# SERVICE BULLETIN

No. 527

Piper Aircraft Corporation

Electric Trim Switch Modification

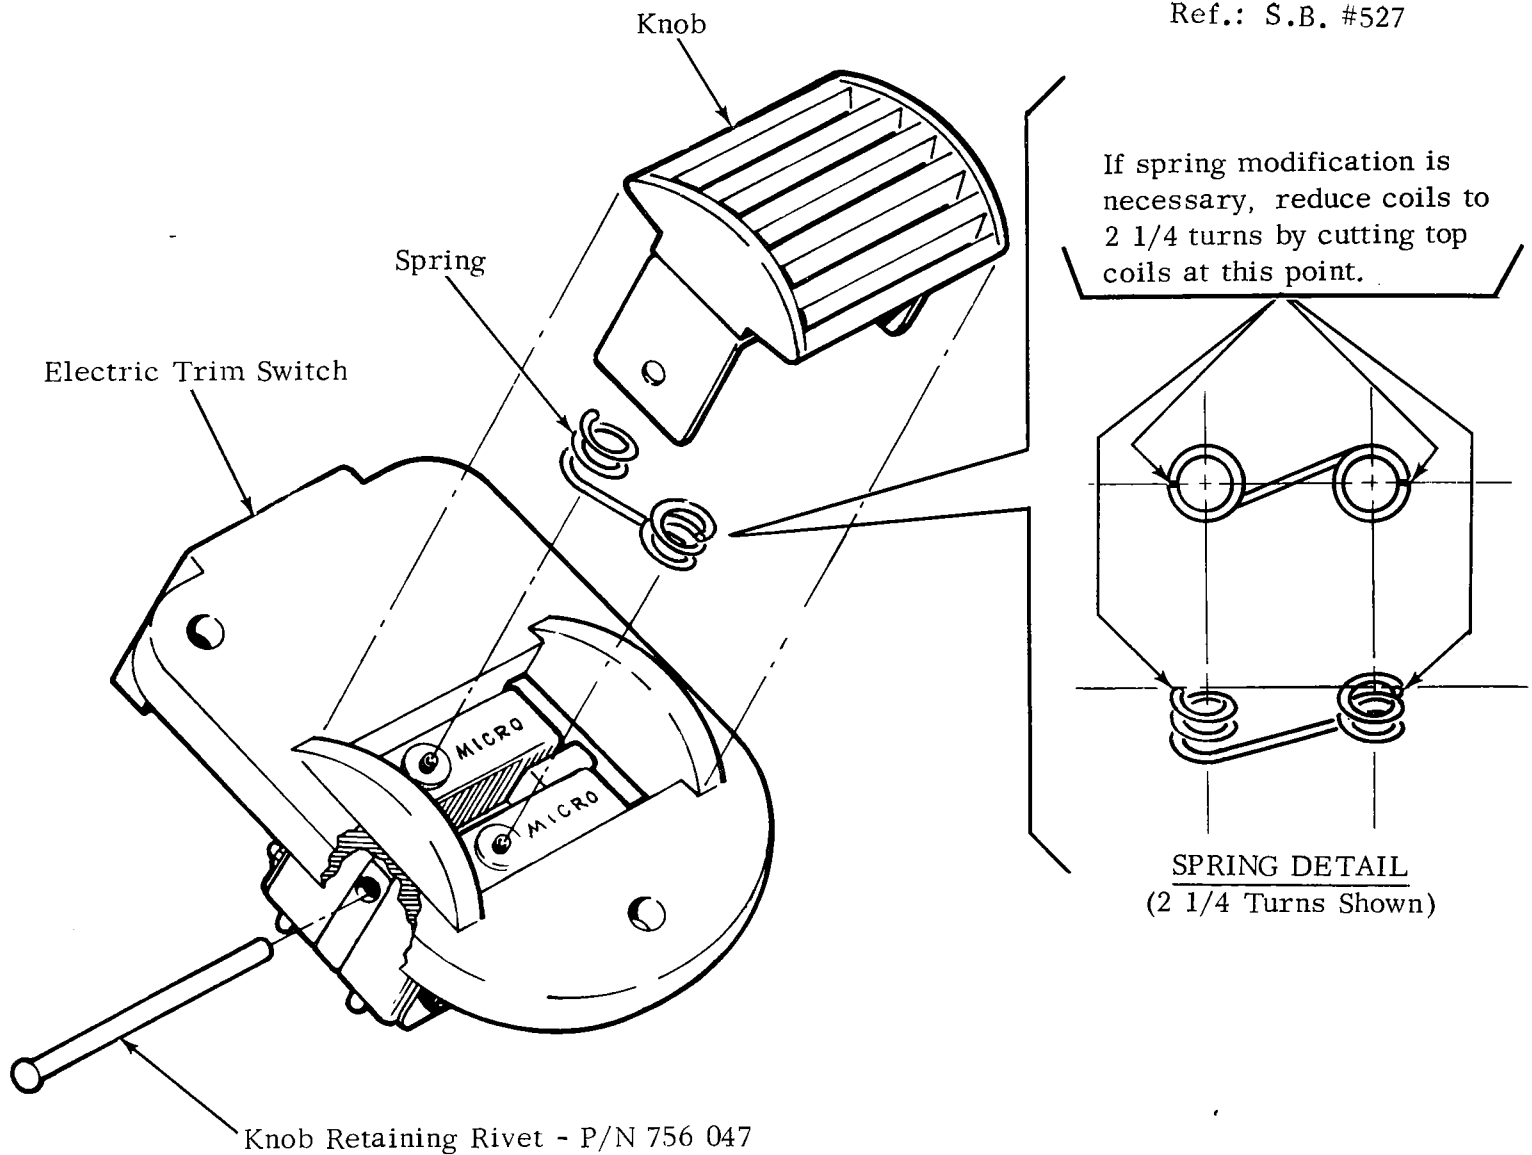
Purpose: Field reports describe a condition wherein the pilot's control wheel mounted "rocker" type electric trim switch tends to "hang up" in the "FWD"/"NOSE UP" or "AFT"/"NOSE DOWN" mode; i.e., fails to return to the "neutral" position following removal of thumb pressure. This condition occurred on some aircraft modified in accordance with Service Bulletin No. 331. Subsequent investigation revealed that the switch return coil springs supplied with Piper Kit No. 760 505 (Electric Trim Switch Modification), per Service Bulletin No. 331 and subsequent production modified models--for a period of time--had an excessive number of coils, which may cause the end of the coil spring to become caught between the switch "rocker" actuator and the micro switch body, thus preventing spring assisted return of the switch to "neutral".

To remedy--and prevent--this condition, this service release provides instructions to modify the electric trim switch return spring by reducing the number of coils (from 2 1/2 turns to 2 1/4 turns--reference attached sketch/instruction sheet for an illustrated view of this condition).

NOTE: It will be necessary to replace the switch knob retaining rivet, as the rivet head is removed to enable switch knob removal.

1. Carefully remove placards from electric trim switch.
2. Remove two screws which secure the switch to the control wheel and remove switch.
3. Remove knob retaining rivet by filing peened or crimped head and carefully knocking out.

4. Remove knob and spring from switch.
5. Inspect spring to determine if coils consist of 2 1/4 turns as shown in above detail or 2 1/2 turns.
  - a. If coils consist of 2 1/4 turns, proceed to Step 6.

- b. If coils consist of 2 1/2 turns, modify spring by cutting 1/4 turn from top of coils before proceeding to Step 6. Refer to spring detail above.
6. Place spring (P/N 757 685 - Scott #10004324) over micro-switch buttons with open ends of spring facing up. Spring coils must be concentric with micro-switch buttons and shoulders, and must not rest upon them.

7. Place knob in position and depress slightly so that the new retaining rivet (P/N 756 047 - Scott # 36270) can be installed. Take care not to dislodge spring from position.

8. Test switch action.
9. Crimp or peen end of retaining rivet to retain.
10. Reinstall switch on control wheel with existing screws and cement placards to switch.
